CALIFORNIA INSTITUTE OF TECHNOLOGY
MASSACHUSETTS INSTITUTE OF TECHNOLOGY
Laser Interferometer Gravitational Wave Observatory (LIGO) Project

To/Mail Code:	
From/Mail Code:	Daniel Sigg
Phone/FAX:	
Refer to:	LIGO-T040129-00
Date:	June 9, 2004

NEW ISCT4 LAYOUT AND AS SIGNAL PATH

Figure 2: Schematic view of proposed H1 ISCT1 layout (AS path only).

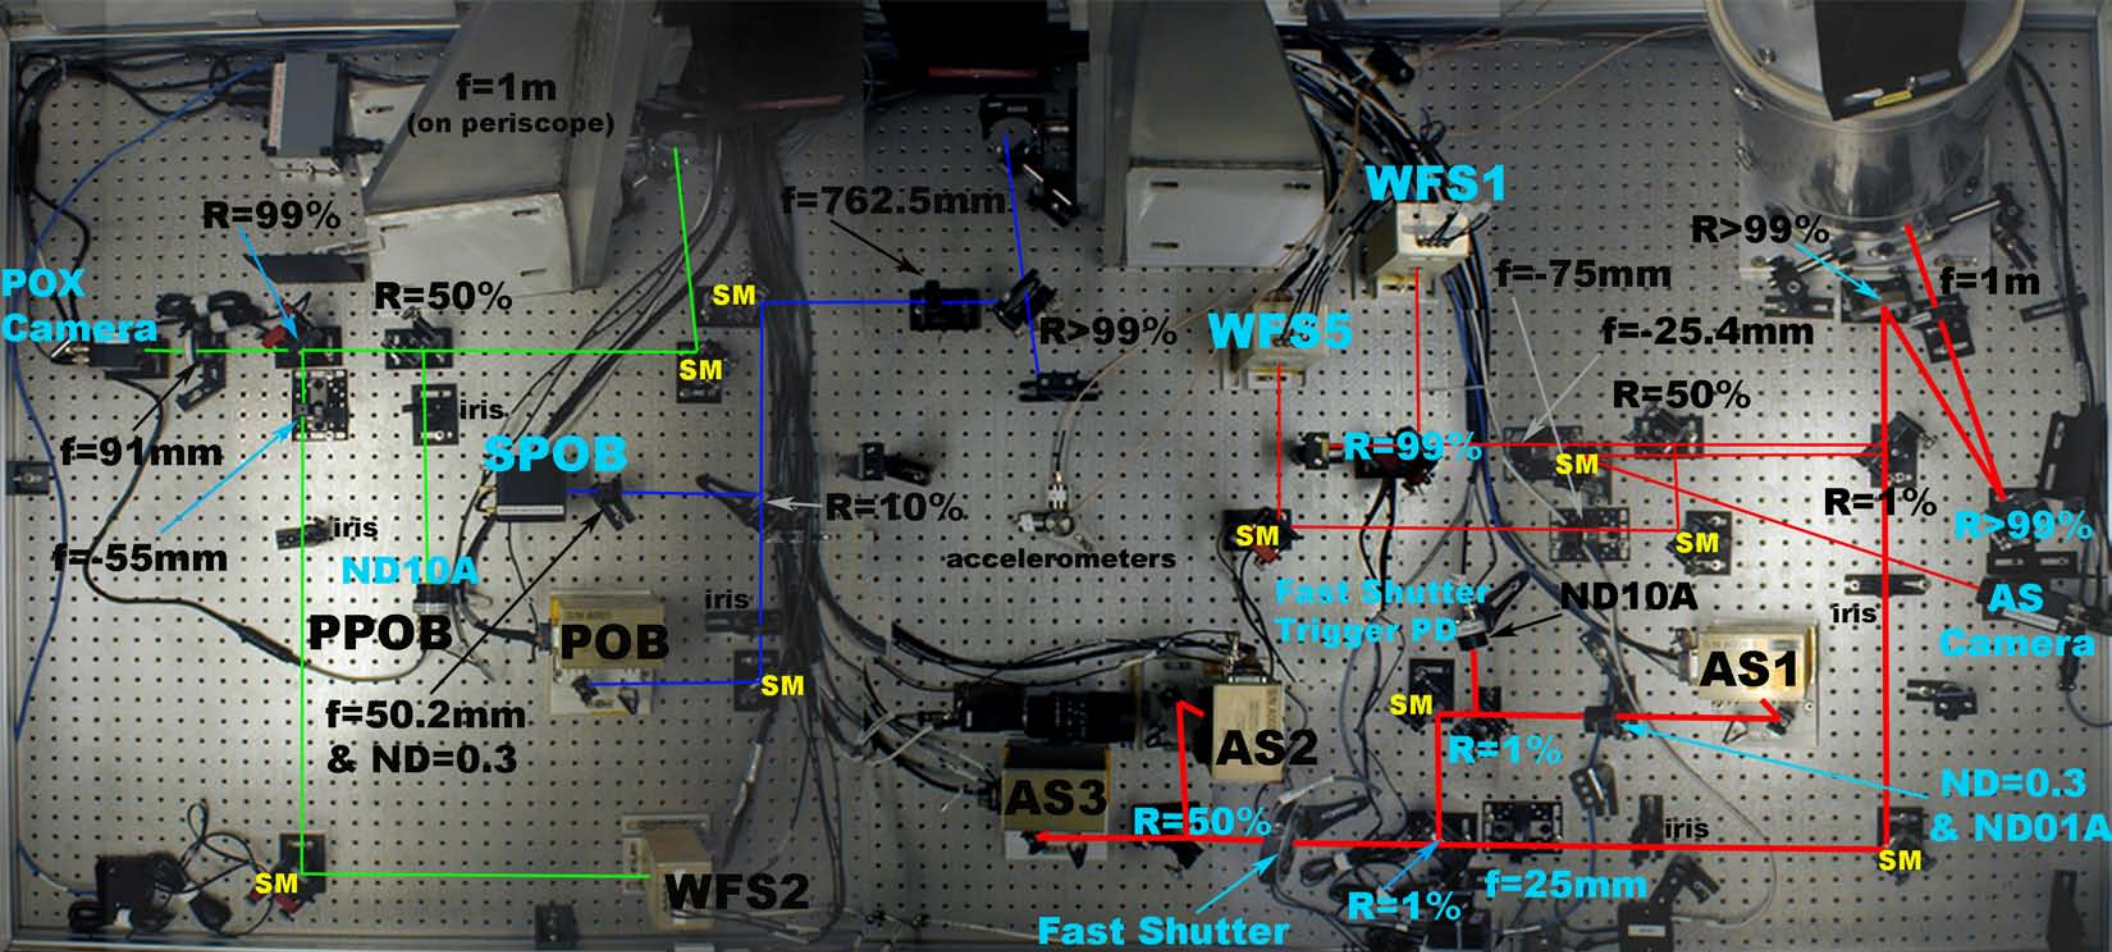
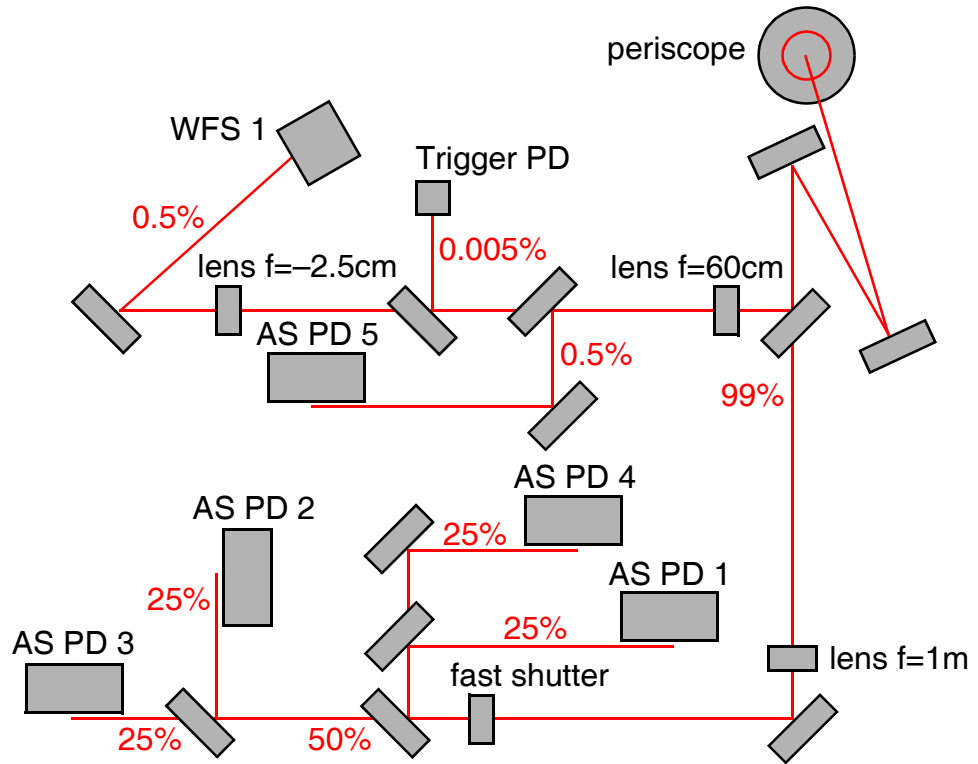
To accommodate a total of four photodetectors at the anti-symmetric port for detection we propose a new layout of ISCT4. To minimize the coupling from dust particles falling through the beam we avoid an intermediate focus.

Figure 2 presents the new layout of ISCT4. The main features are:

- The focusing lens has been moved after the WFS split. The WFS path implements a new 600mm lens whereas the LSC path keeps the 1000mm lens. There is no intermediate focus anymore in the LSC path.
- The locking PD moves to the old WFS5 path and is now called AS PD5. The trigger PD is moved to the WFS path as well.
- New photodetectors for detection are installed in the LSC path: AS PD 1 and AS PD 4.
- The diverging lens in front of WFS1 is moved back to account for the translation and change of focal length of the upstream lens.
- The OMC work can be continued at the AS PD2 path if necessary.
